BROWNS FERRY NUCLEAR PLANT (BFN) – UNITS 1, 2, AND 3 – TECHNICAL SPECIFICATIONS (TS) CHANGES TS-418 AND TS-431 – EXTENDED POWER UPRATE (EPU) – RESPONSE TO ROUND 23 REQUEST FOR ADDITIONAL INFORMATION (RAI) REGARDING STEAM DRYER SIGNAL PROCESSING (TAC NOS. MD5262, MD5263, AND MD5264)

**TENNESSEE VALLEY AUTHORITY
BROWNS FERRY NUCLEAR PLANT (BFN)
UNITS 1, 2, AND 3**

**TECHNICAL SPECIFICATIONS (TS) CHANGES TS-431 AND TS-418
EXTENDED POWER UPRATE (EPU)**

**RESPONSE TO ROUND 23 REQUEST FOR ADDITIONAL INFORMATION (RAI)
REGARDING STEAM DRYER SIGNAL PROCESSING**

Figure EMCB.202/163-5a. Coherence for BFN1 main steam line A (top) and B (bottom) for CLTP conditions, measured data (black) and EIC removed and notch filtered (red).

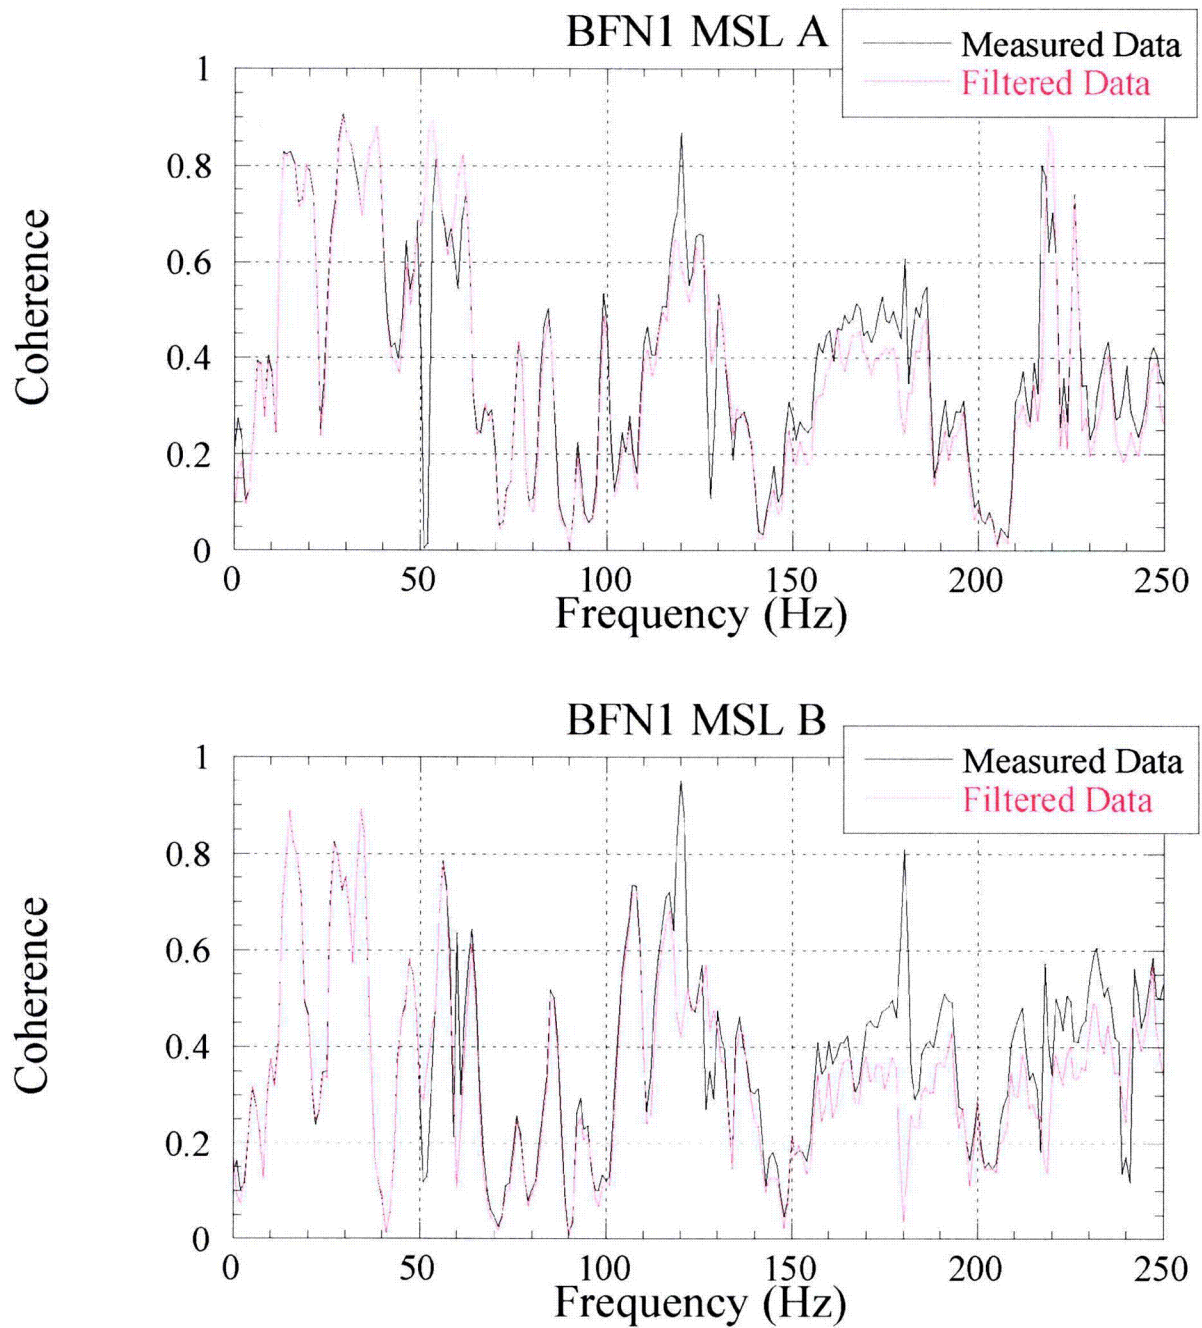
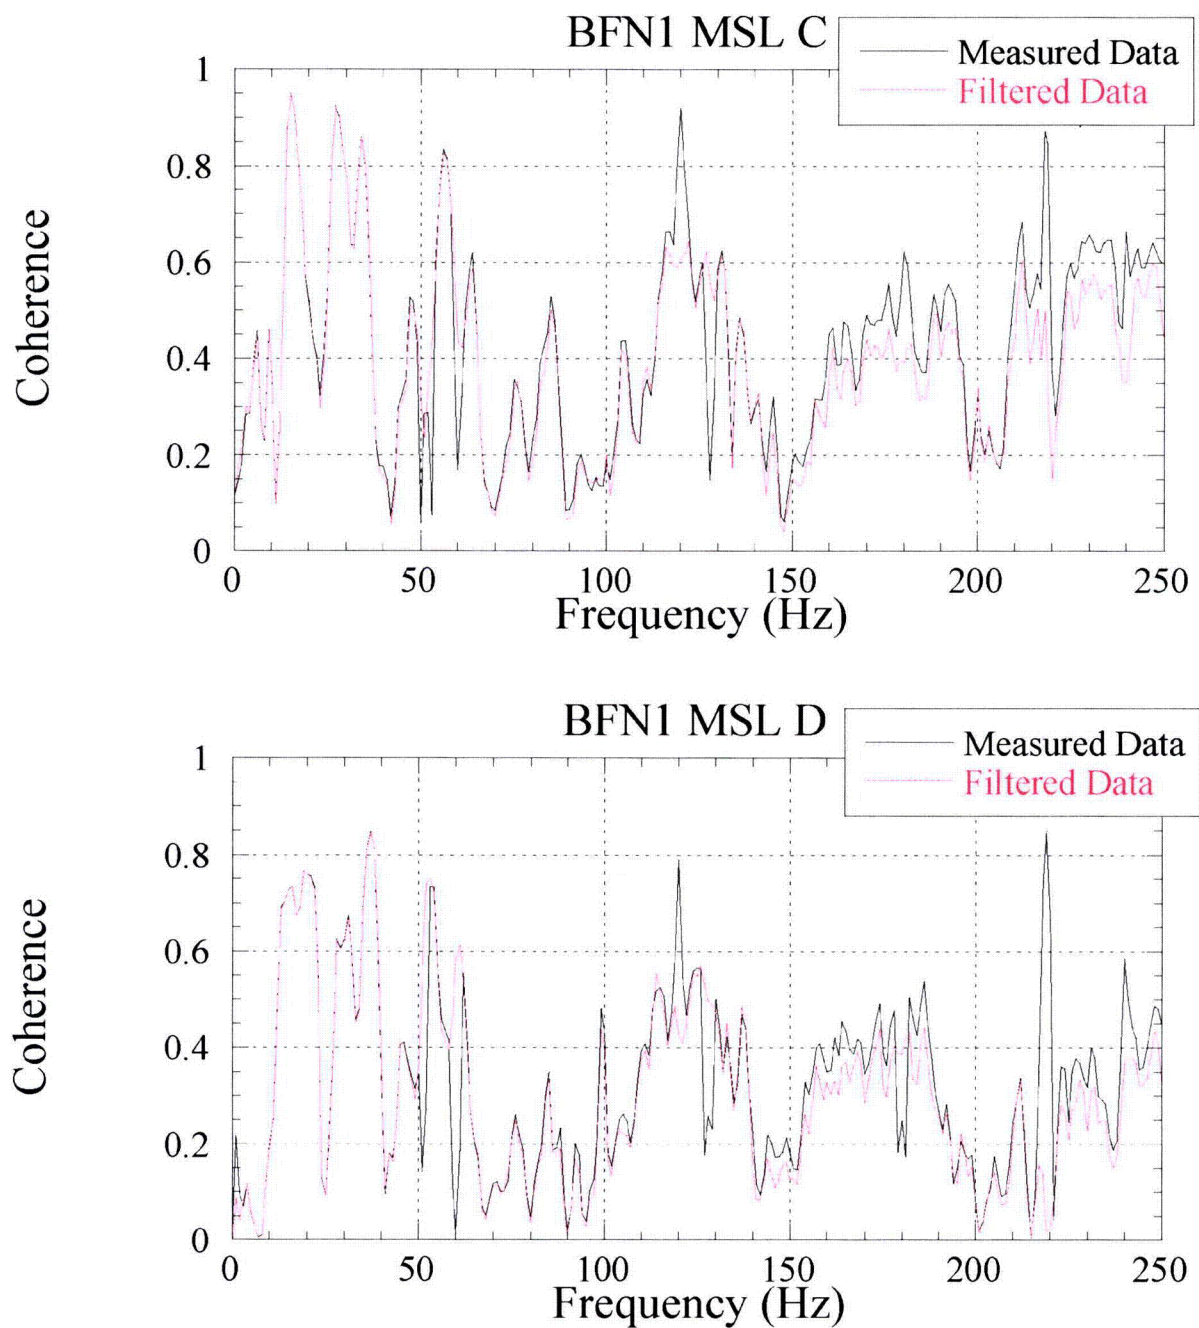
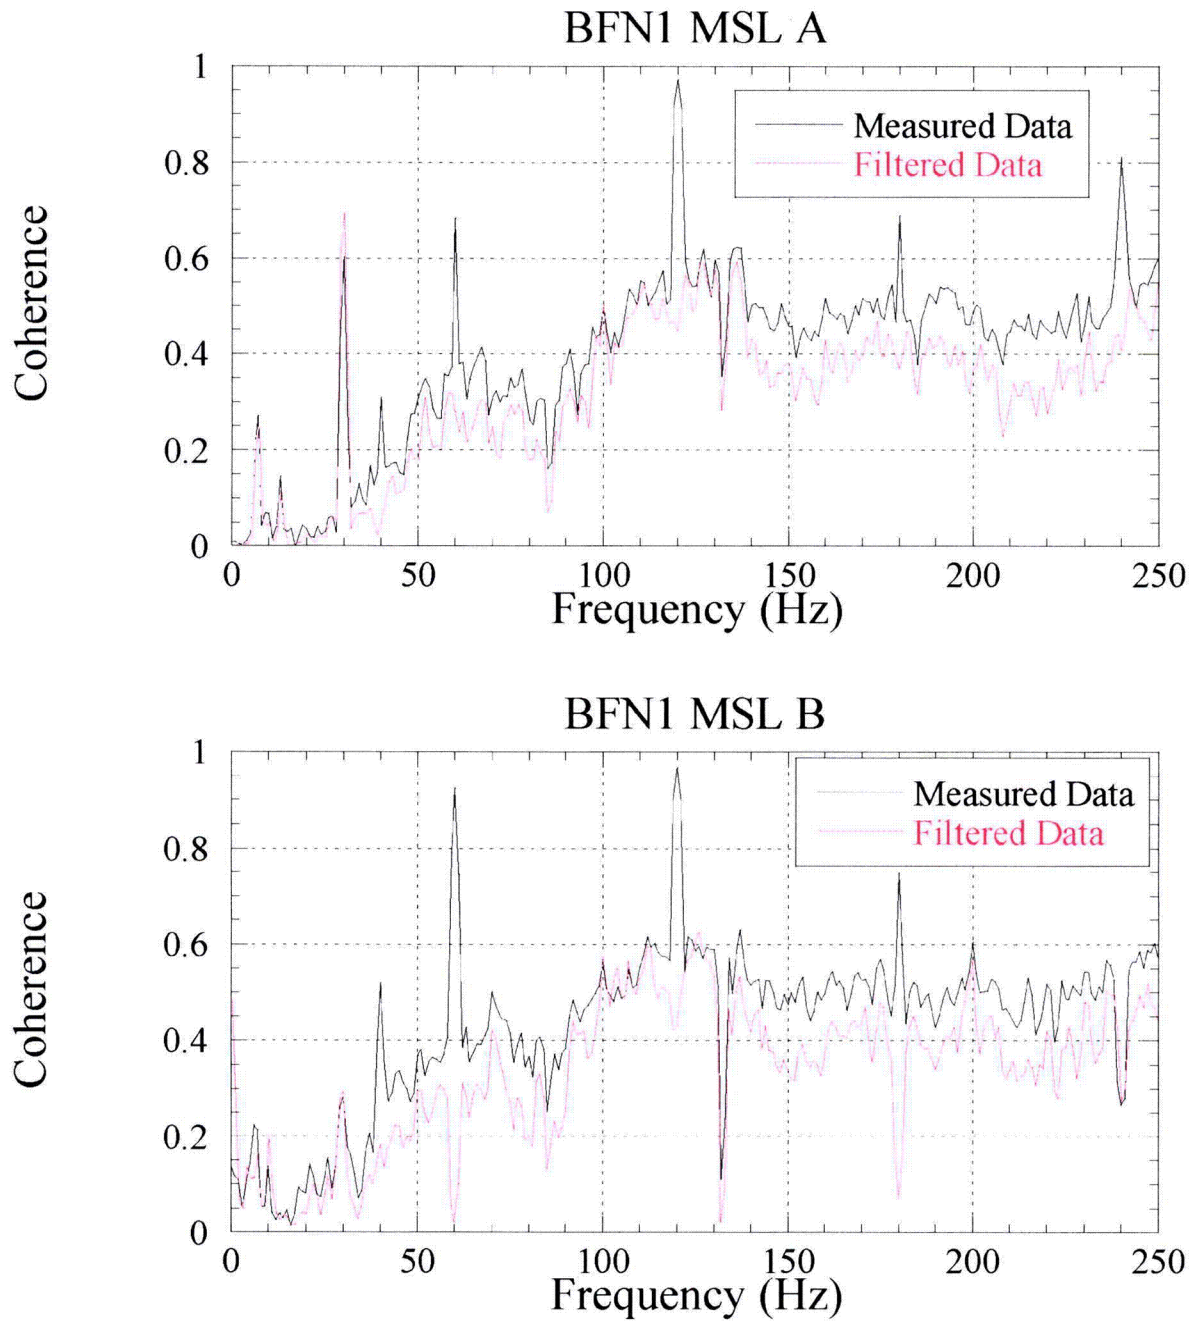
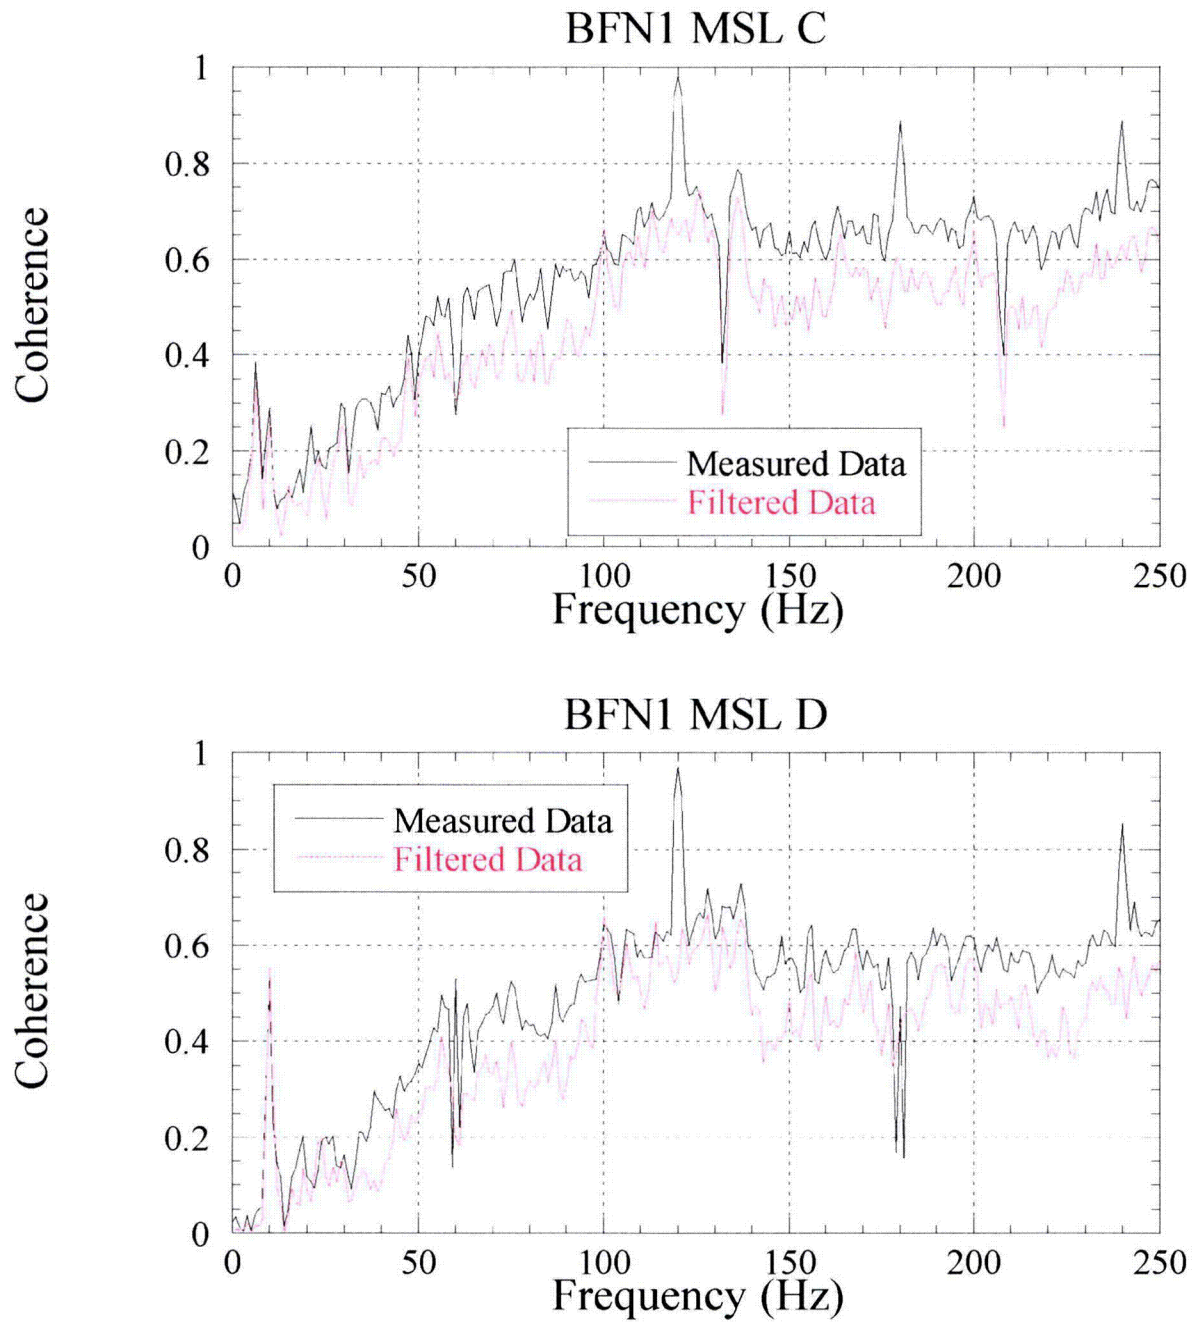
where G_{12} is the cross-spectrum between the two signals, and G_{11} and G_{22} are the autospectra of the individual signals. Explain how G_{12} is modified after using EIC signals and notch filters prior to being used in the coherence calculation. This explanation should include how both the magnitude and phase of G_{12} are modified.

would seem more relevant as it is used to condition the CLTP and LF data sets. Examine Figures EMC.B.202/163-5 and 6 for coherence discussed above to determine that there has been little change in the cross spectrum when normalized by the auto spectra from CLTP and LF, respectively, except at discrete frequencies as expected.
